ADDENDUM #4

Will County Health Department
BID PACKAGE #3 – MEP/Finishes/Carpentry/Glazing
December 6, 2018

RFI LOG
Will County Health Department
Bid Package #3 Addendum #4 12/6/18

2.08 DRAWING A1001 - PLAN DETAILS

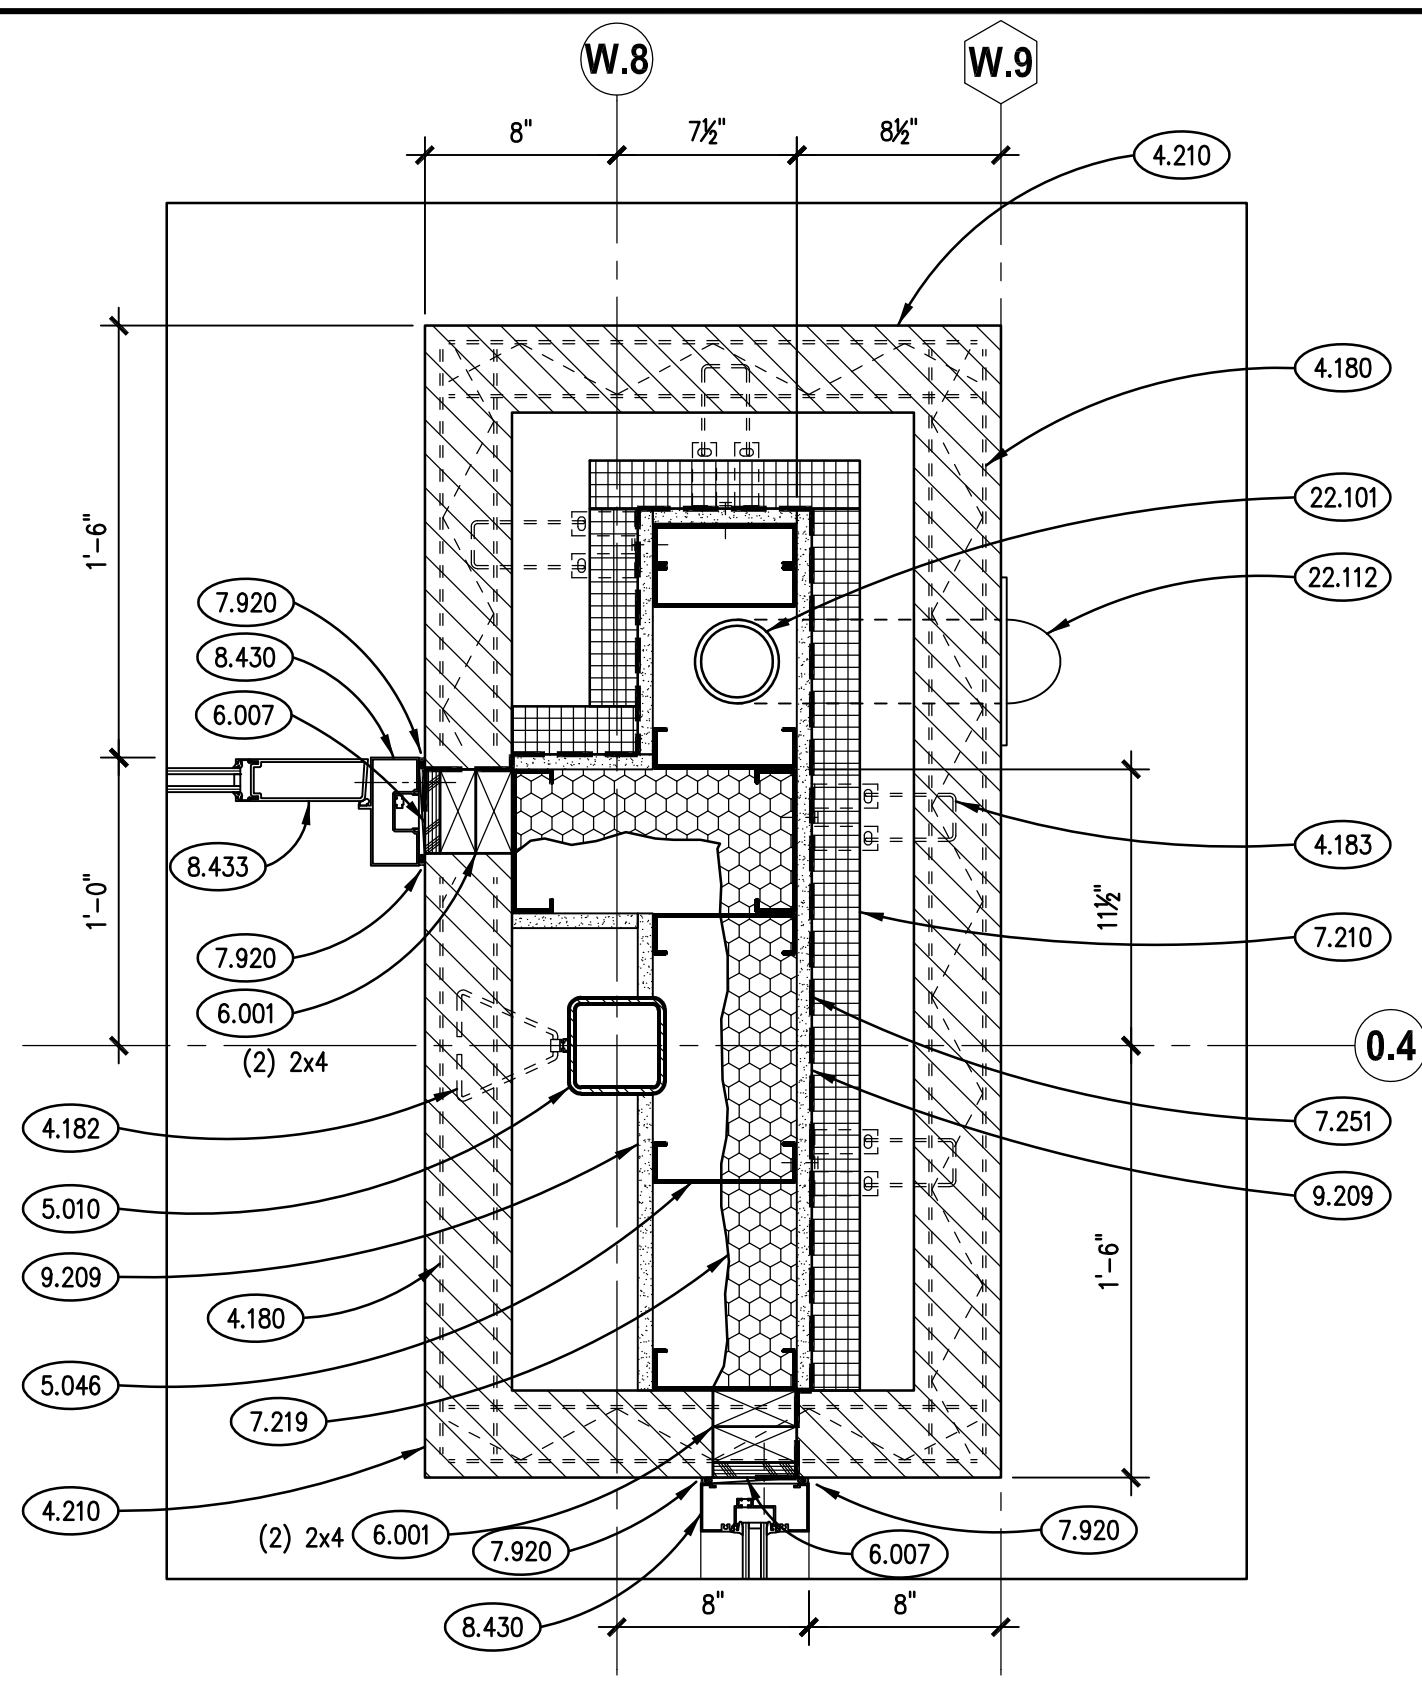
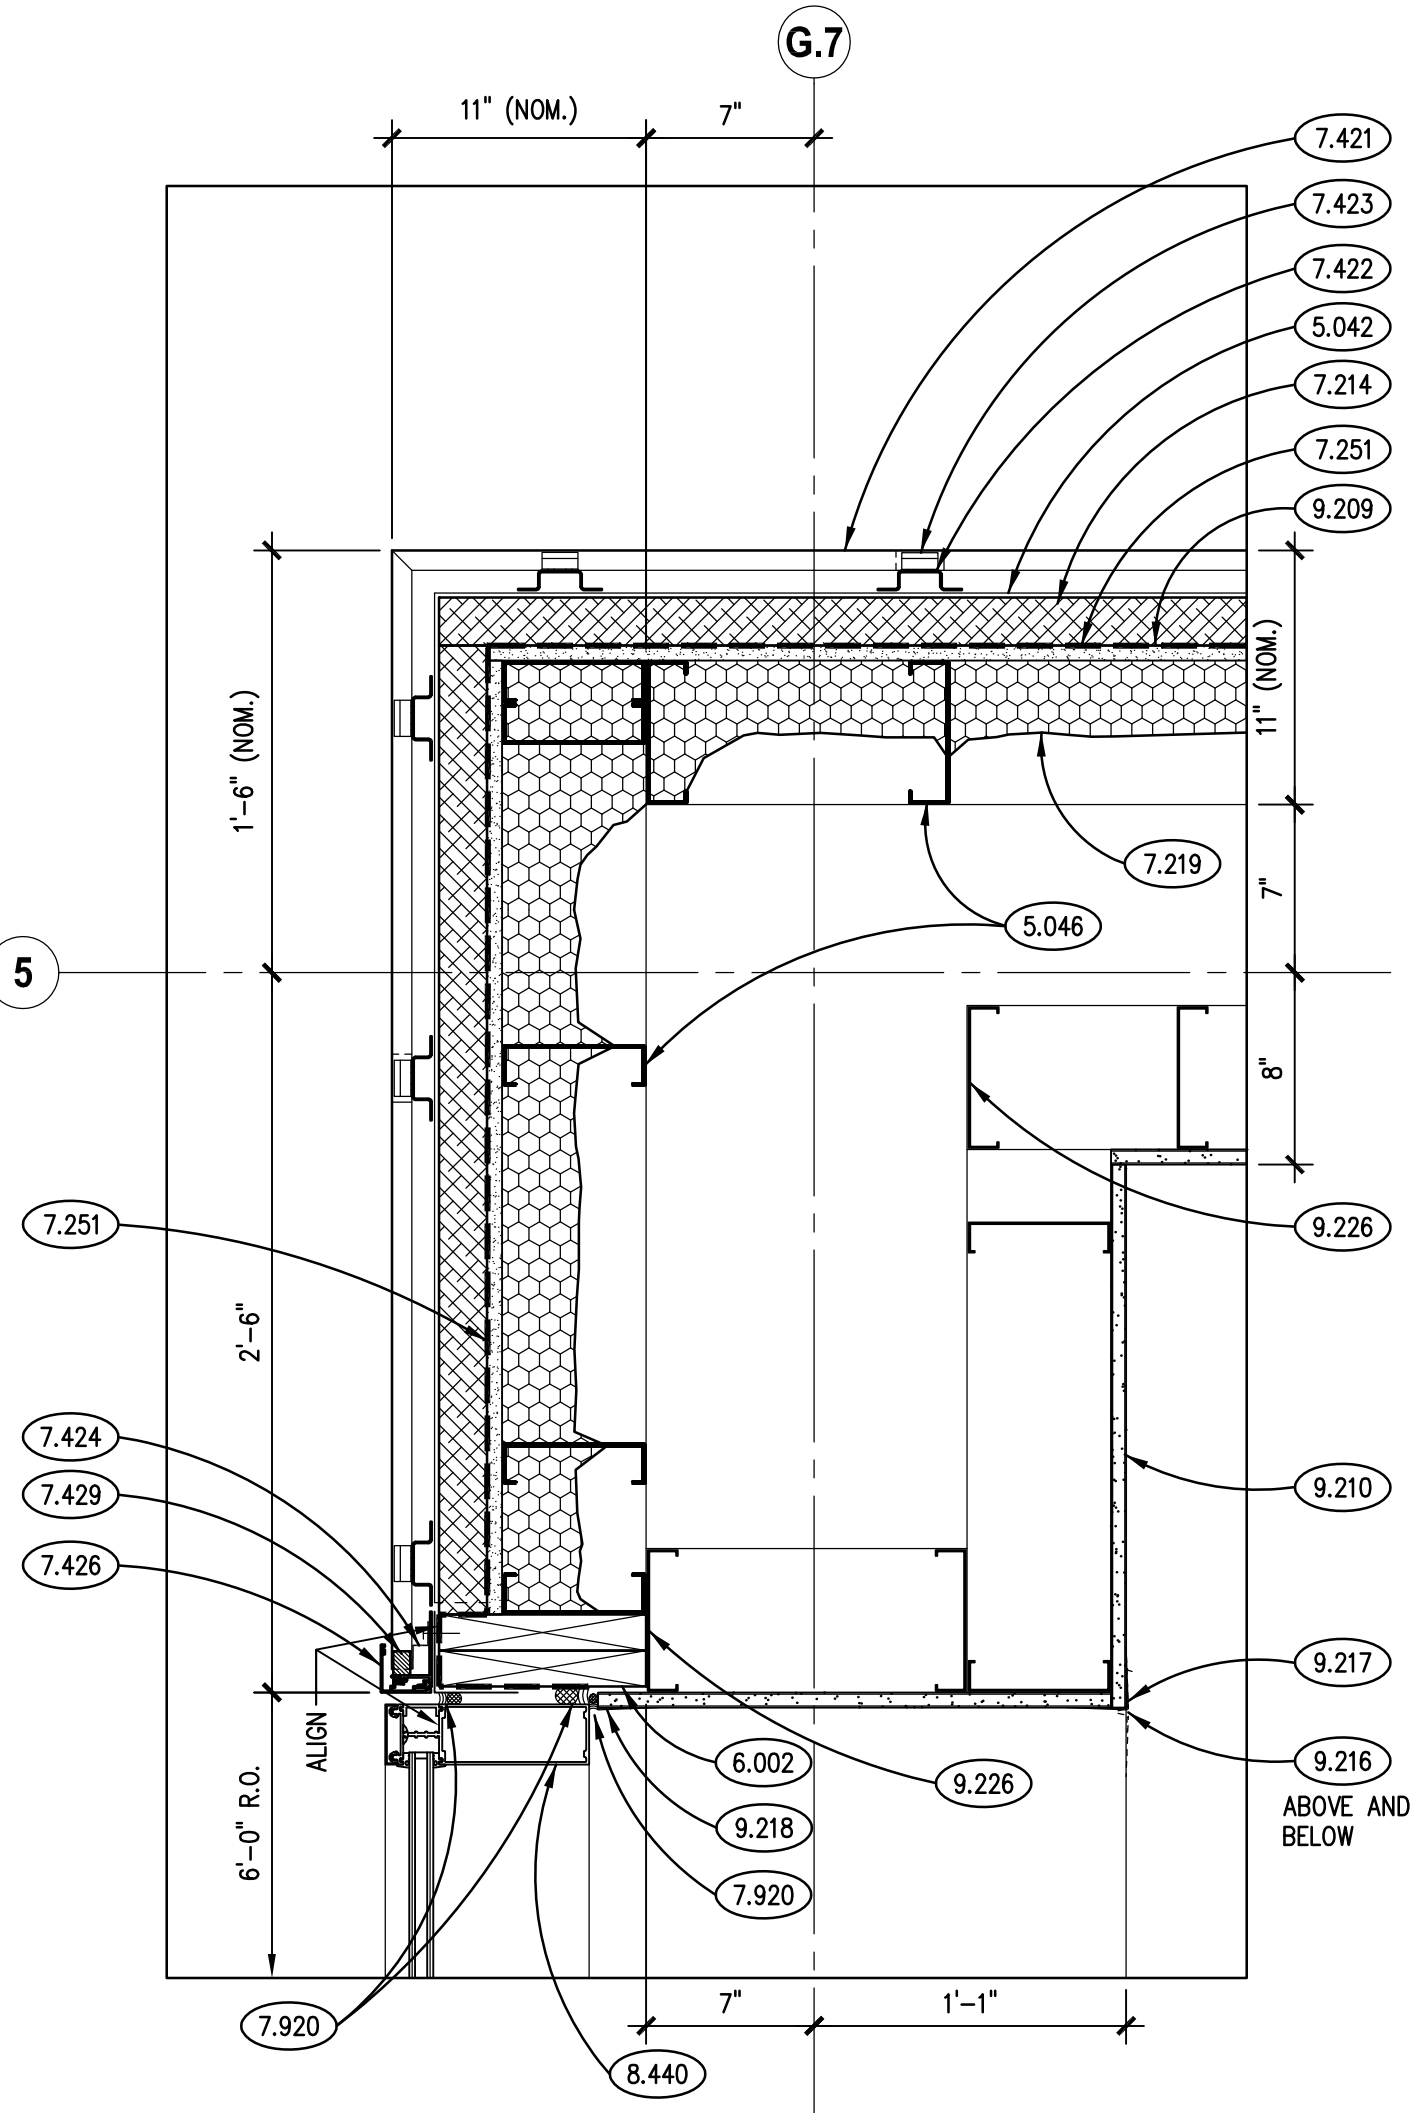
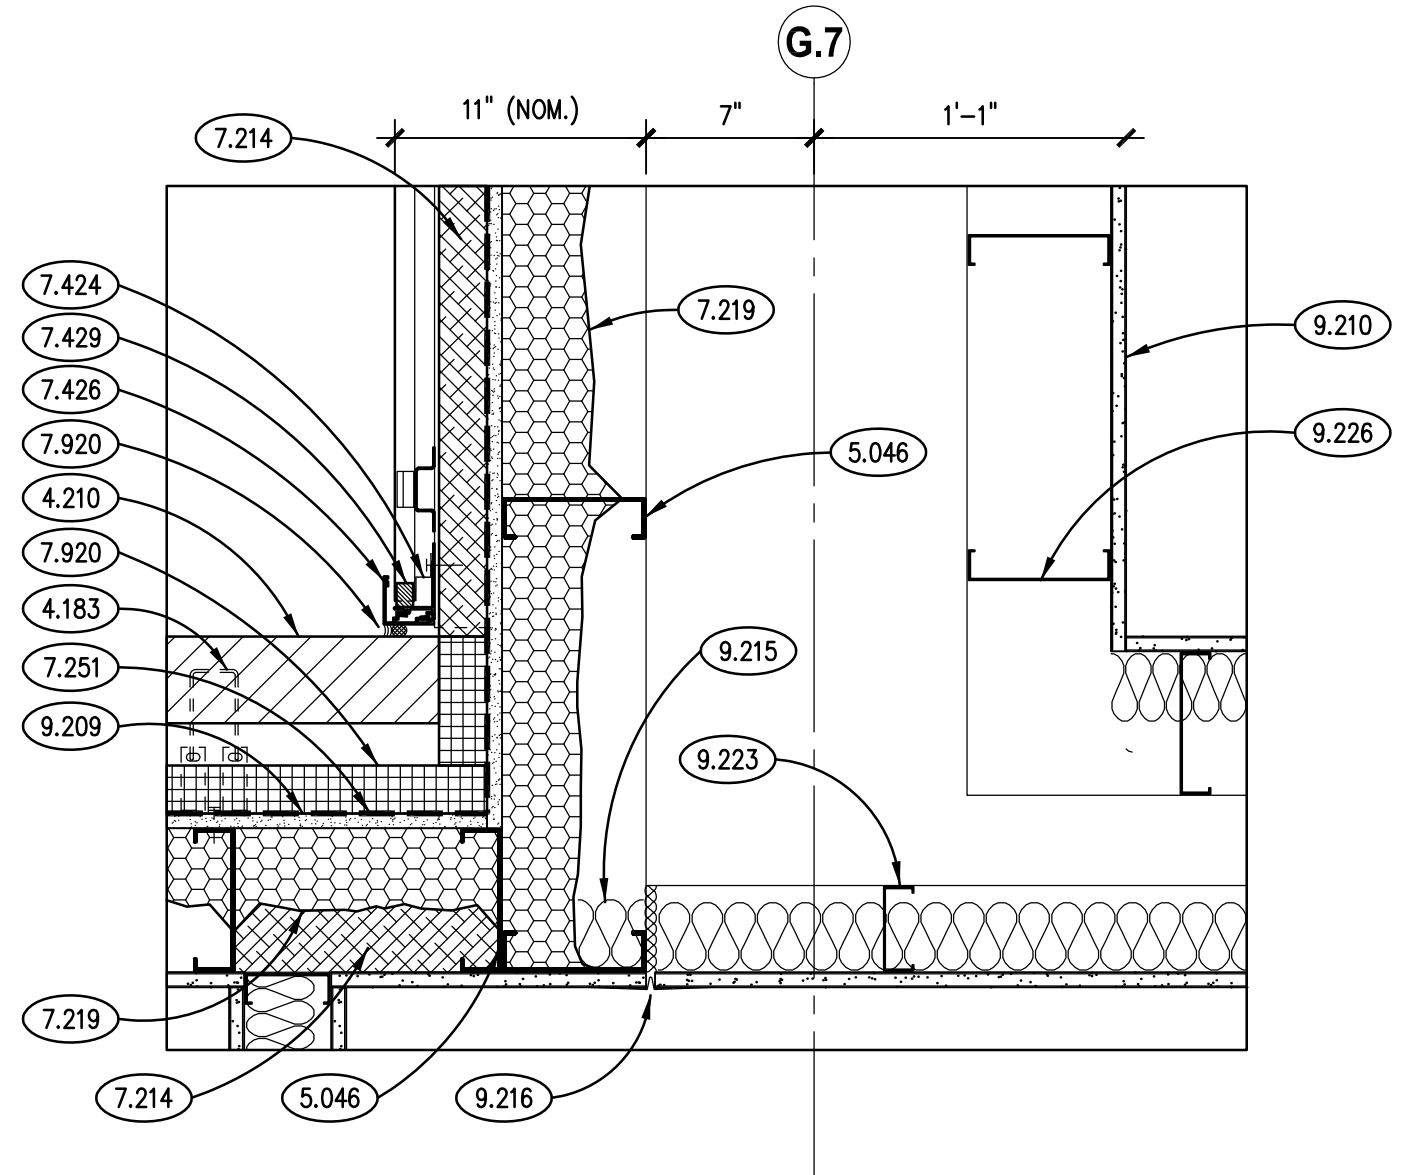
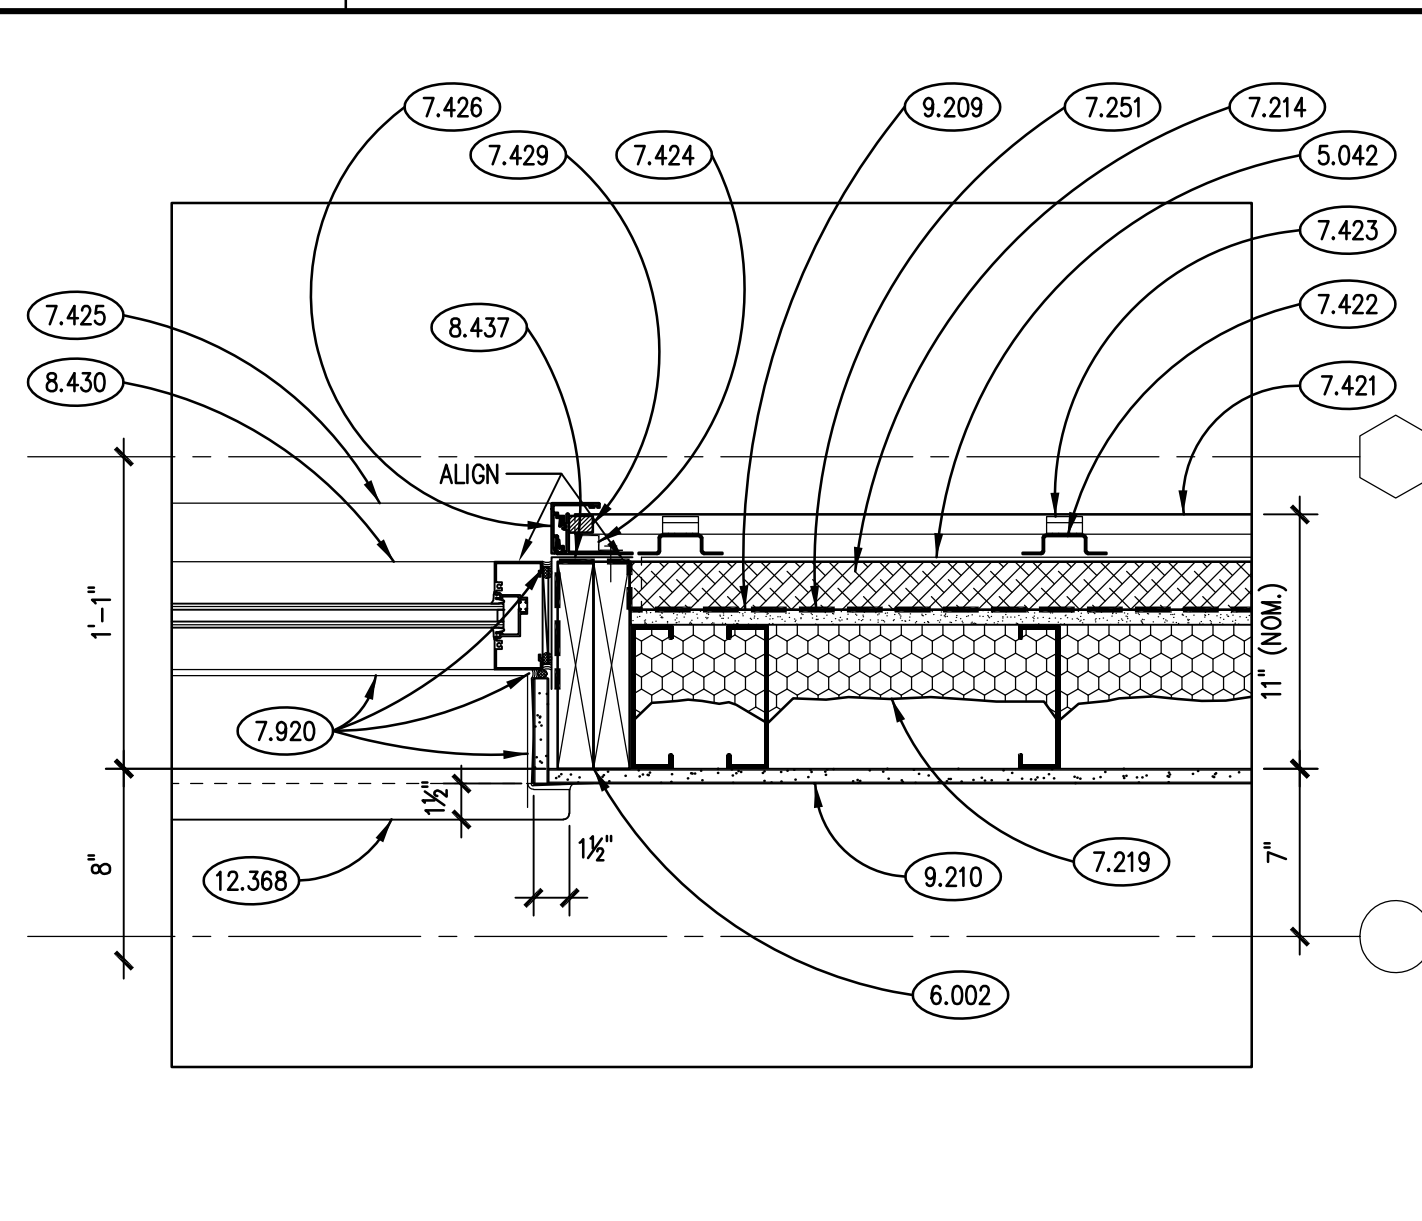
| BP3-060 | Addendum #4 | 6) See detail 1/A1001 for typical interior partition to exterior wall intersect. Keynote 9.213 indicated ½" cement board approx. 1-4"wide behind each location but the hatch width appears to be wider than ½". Should this material be roxul insulation or is the intent to run a strip of ½" cement board full height at those locations? | Detail will be revised by BP#3 - Addendum #4. Keynote will be revised to read 7.213 pointing to the roxul insulation. It is roxul tight behind all intersection walls to the outside wall assembly. Typical all outside walls. | R |

- A. Details 1 & 3: Revise Keynote 9.213 to read 7.213. Refer to attached Sheet A1001 revision cloud #11.
